Re : 2016 Northland Airspace Review

2016 NORTHLAND AIRSPACE REVIEW

APPLICATION TO REVISE WHANGAREI MBZ B171
From AUCKLAND HANG GLIDING & PARAGLIDING CLUB

Northland Airspace Review

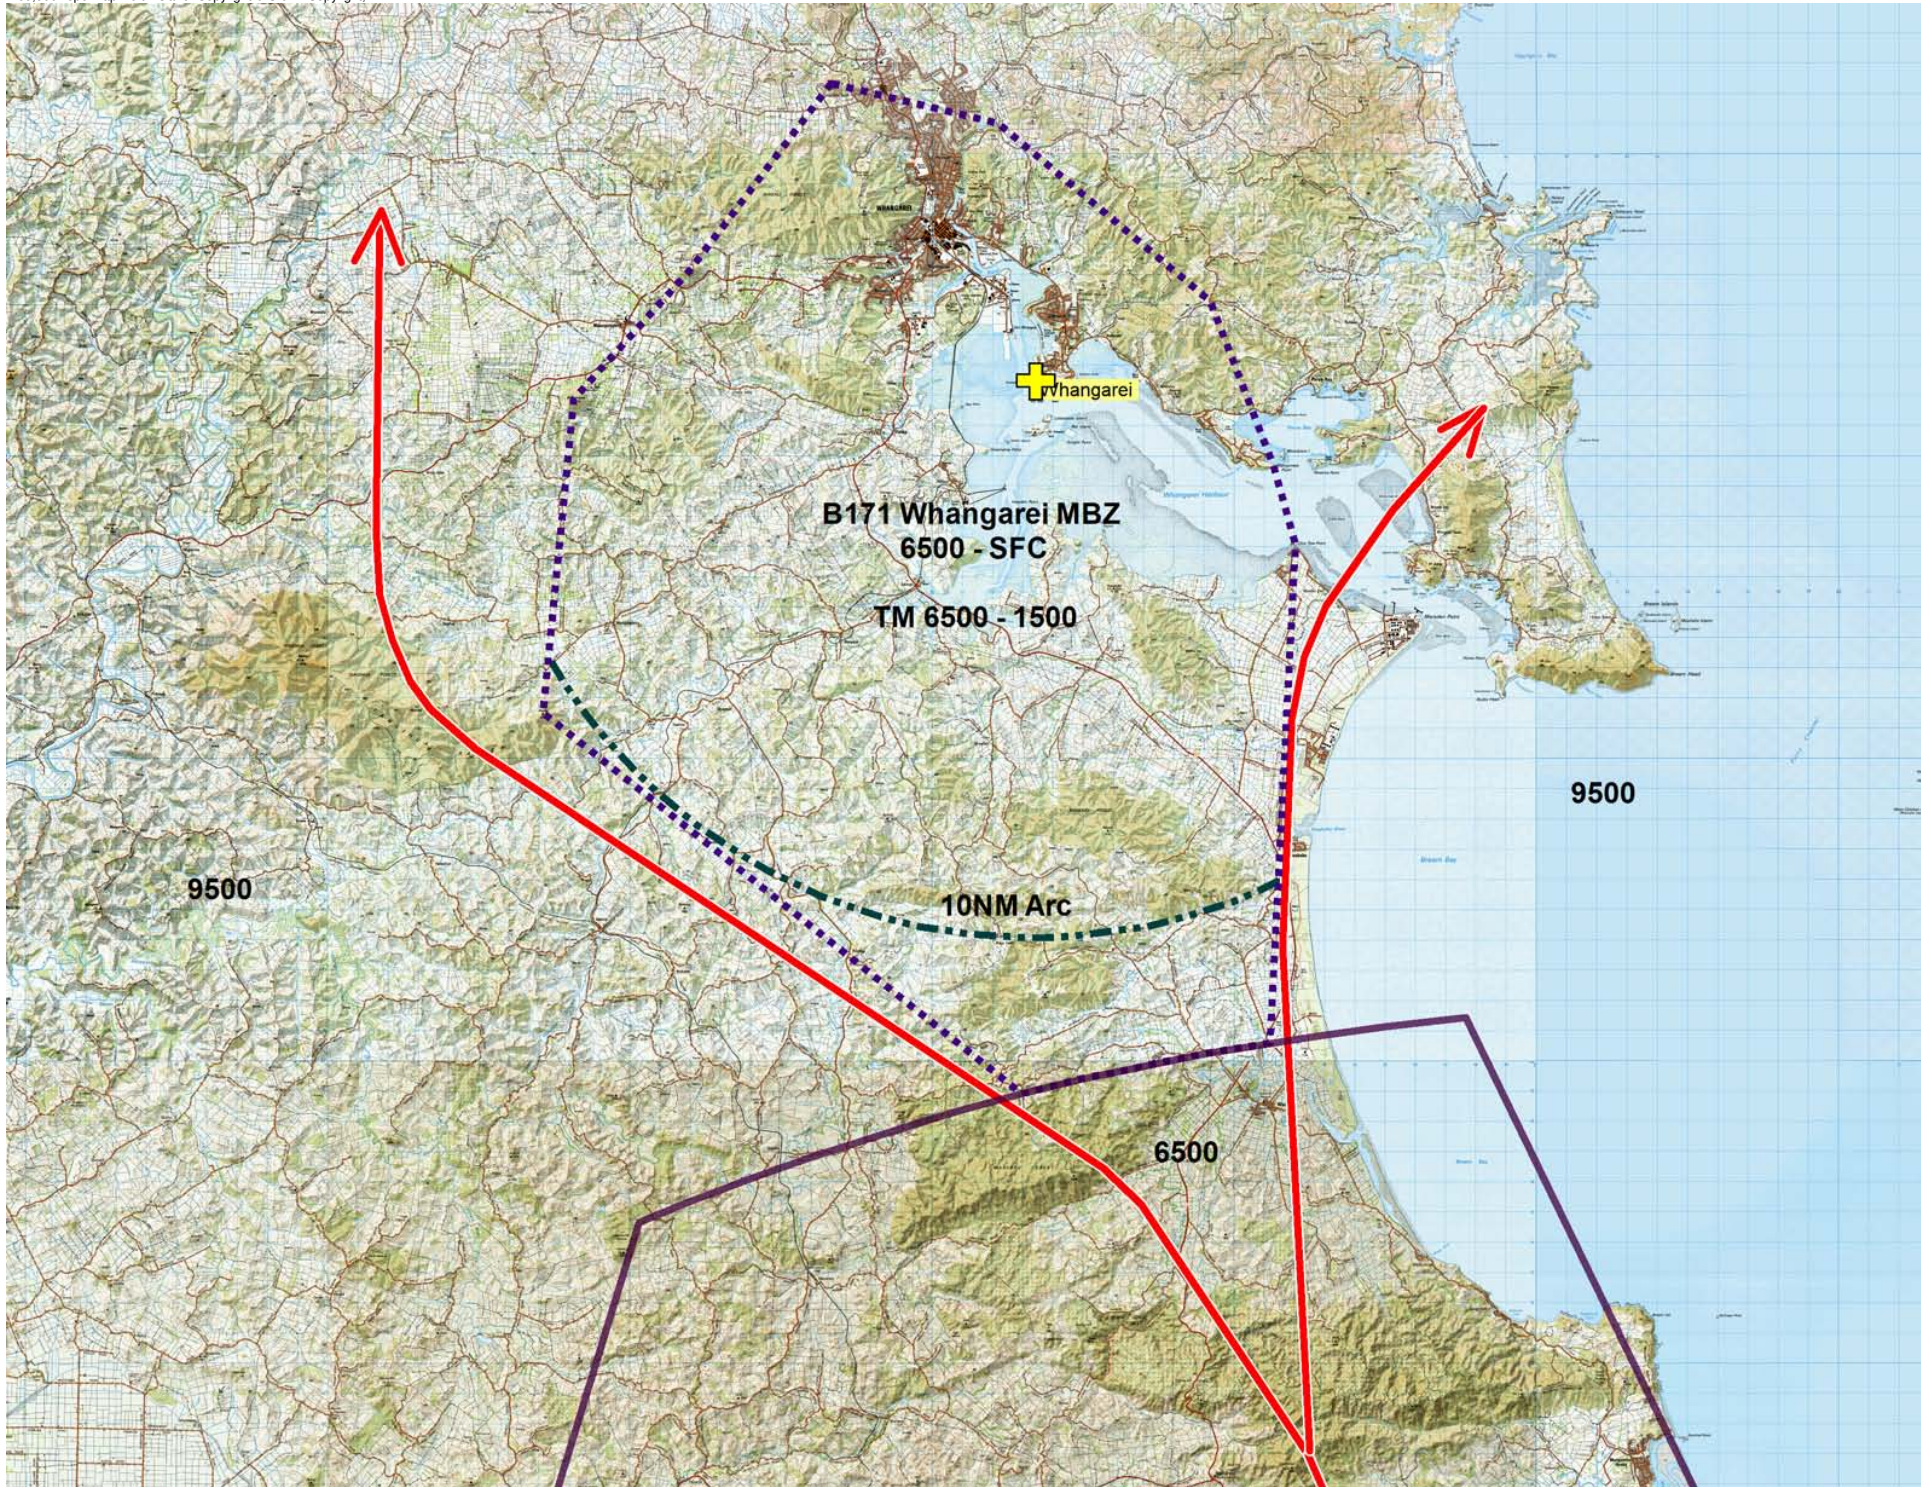
The New Zealand Hang Gliding & Paragliding Association (NZHGPA) is a long established airspace user in Northland
We request that MBZ B171 Whangarei be reduced in size as described below and in the attached documents.

The proposed new boundaries have been drawn using some of the existing MBZ and airspace boundaries and prominent landmarks or features.

Taking this in to account we have mostly kept the proposed boundaries outside a 10NM radius from Whangarei airport.

Boundary Layer Max. Up/Down Motion

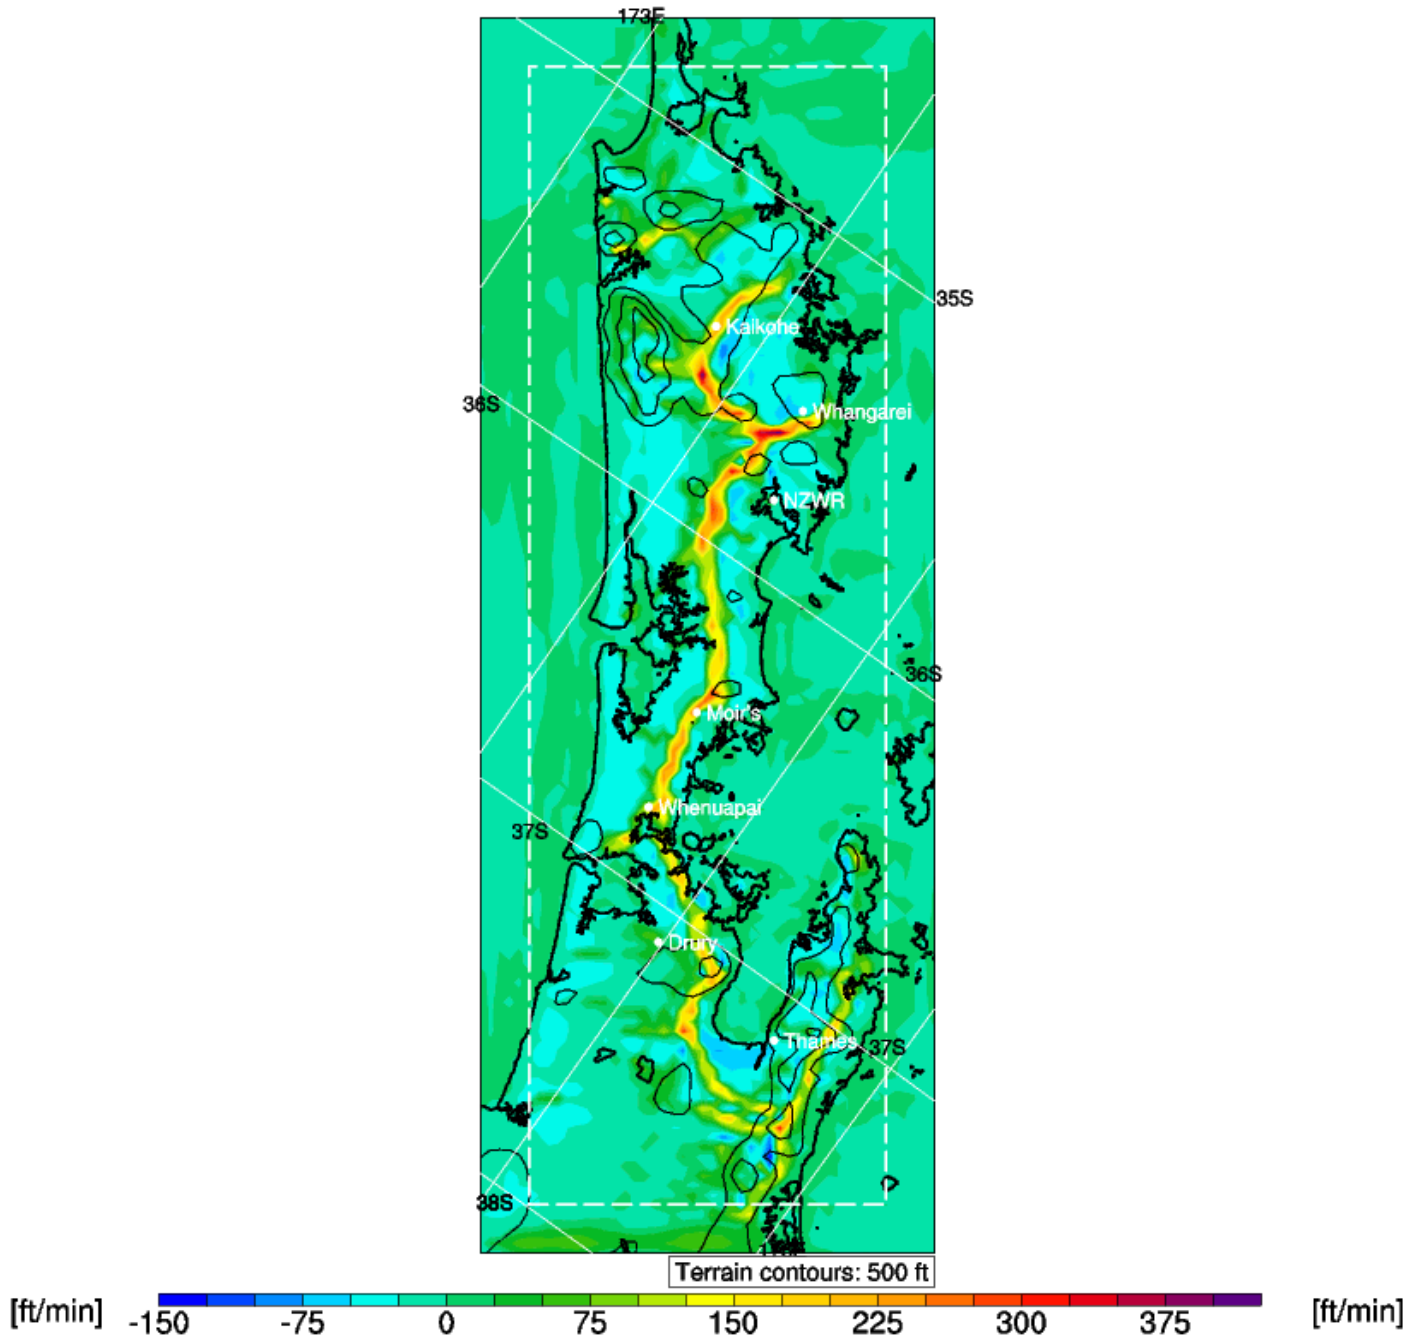
The convergence line typically sets up over MBZ B171, hence our desire to access this area. Refer attached example of a typical convergence forecast for this area. Hang glider and paraglider pilots use this convergence line to carry out long distance cross country flights.

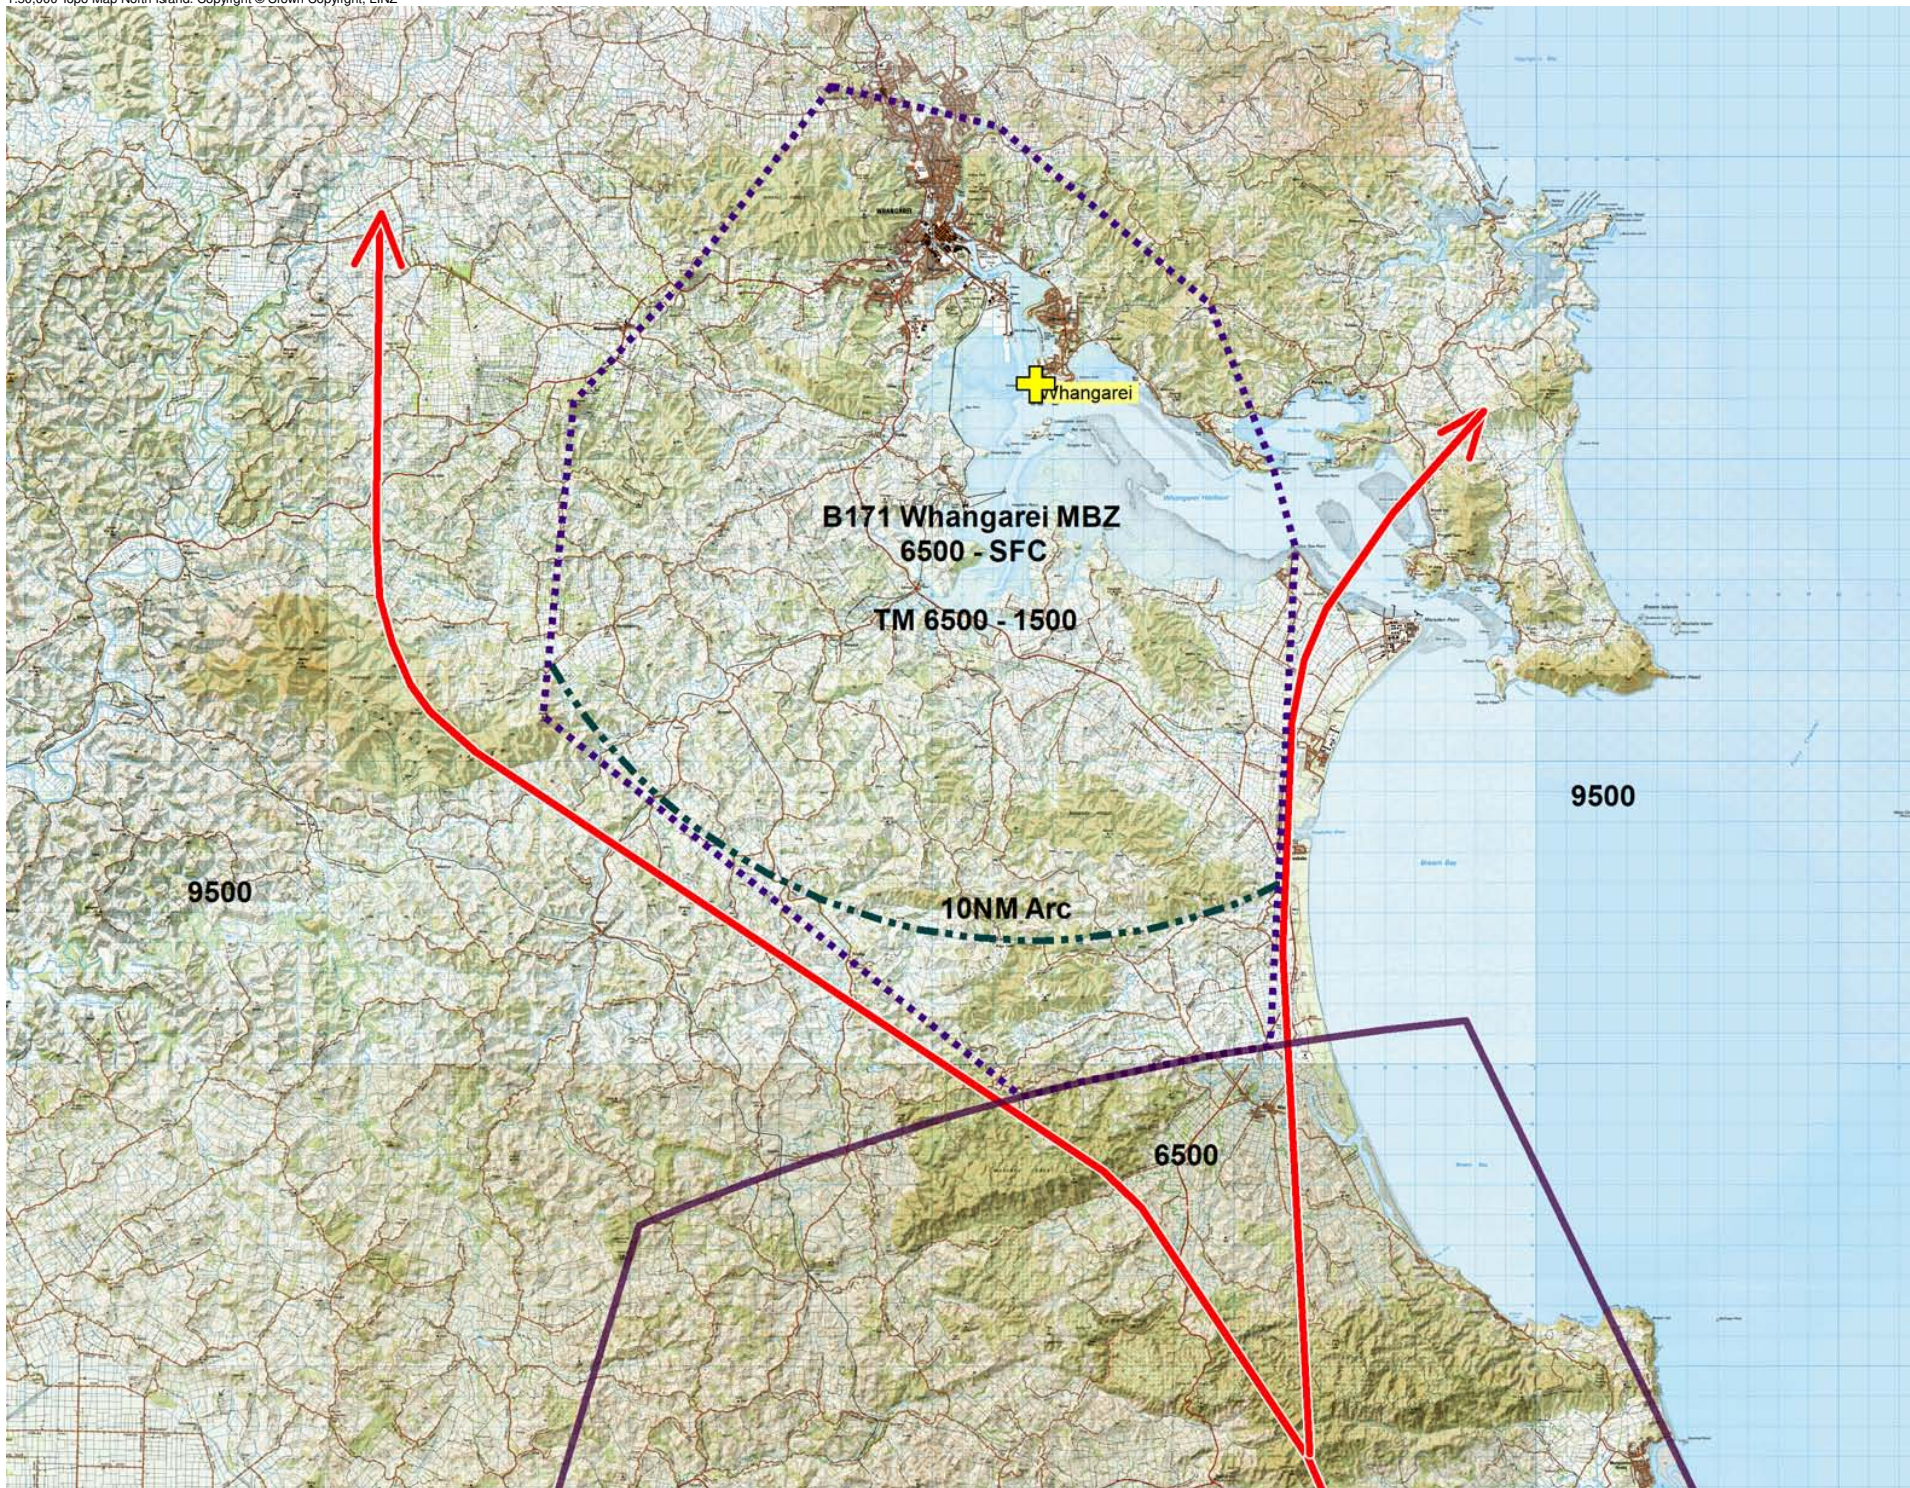
The New Zealand Hang Gliding & Paragliding Association (NZHGPA) is a long established airspace user in Northland
We request that MBZ B171 Whangarei be reduced in size as described below and in the attached documents.

The proposed new boundaries have been drawn using some of the existing MBZ and airspace boundaries and prominent landmarks or features.

Taking this in to account we have mostly kept the proposed boundaries outside a 10NM radius from Whangarei airport.

Boundary Layer Max. Up/Down Motion

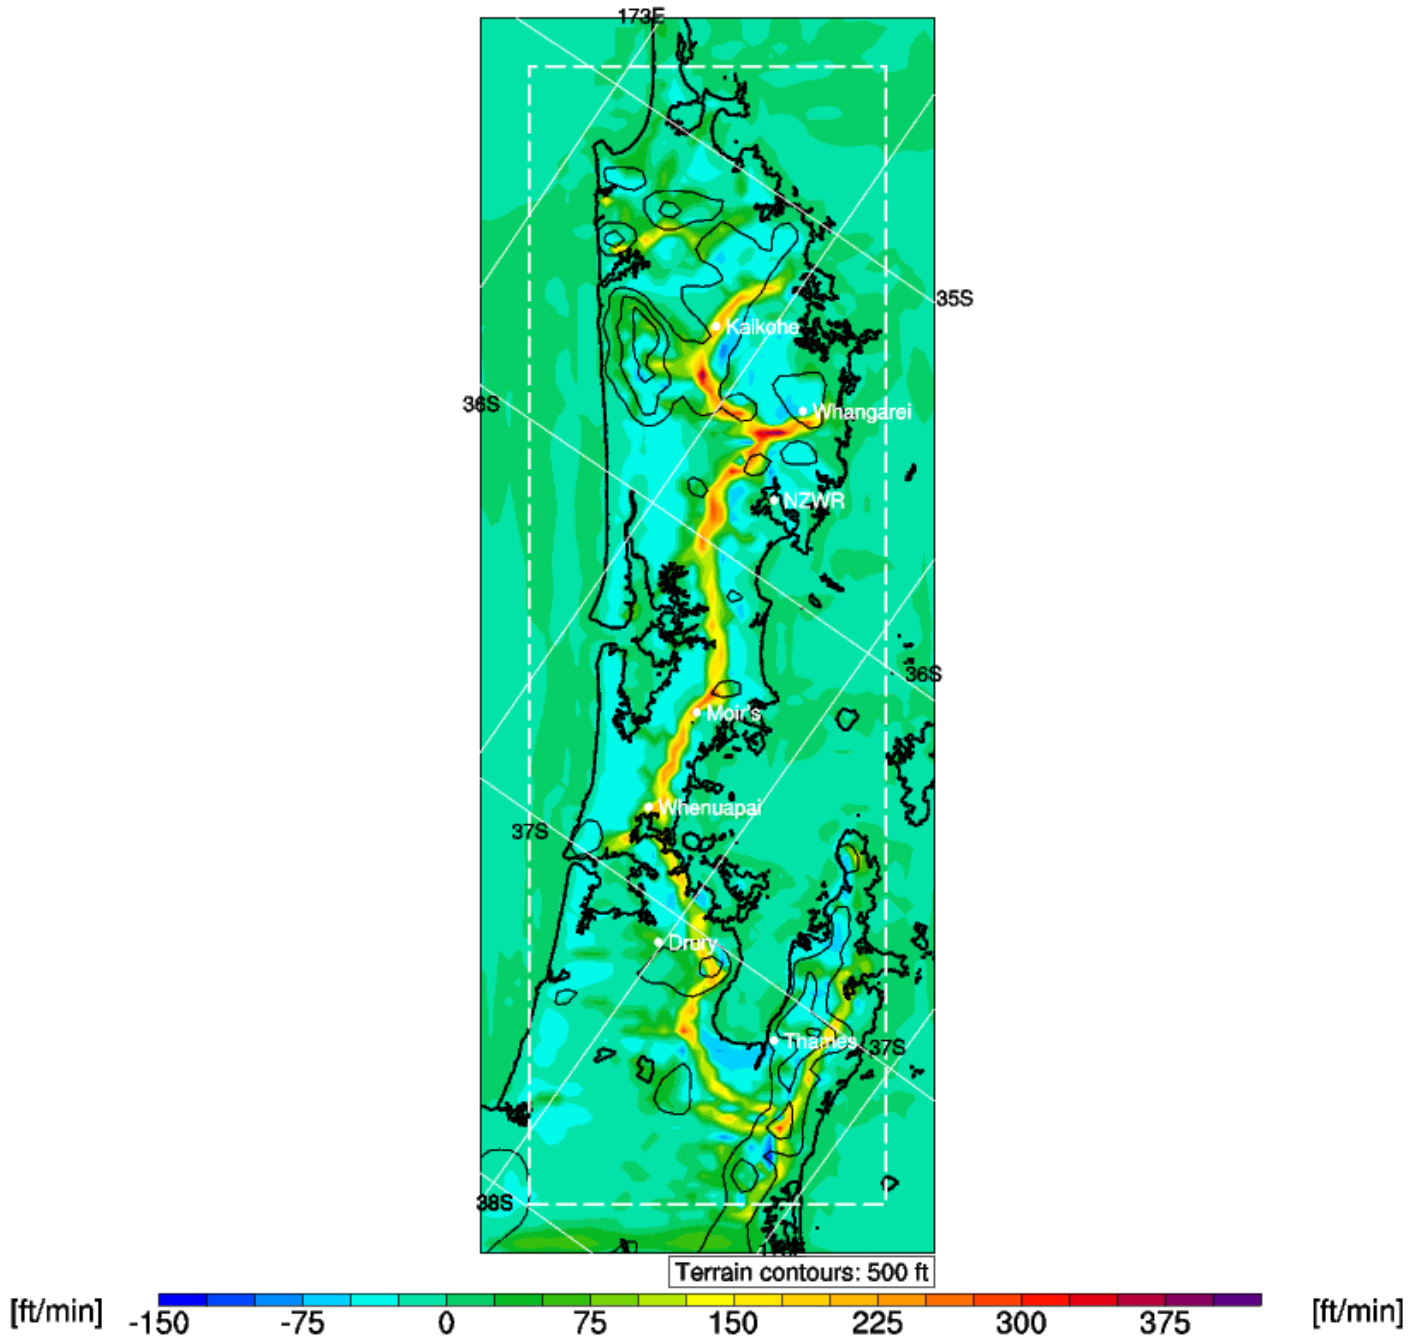
The convergence line typically sets up over MBZ B171, hence our desire to access this area. Refer attached example of a typical convergence forecast for this area. Hang glider and paraglider pilots use this convergence line to carry out long distance cross country flights.
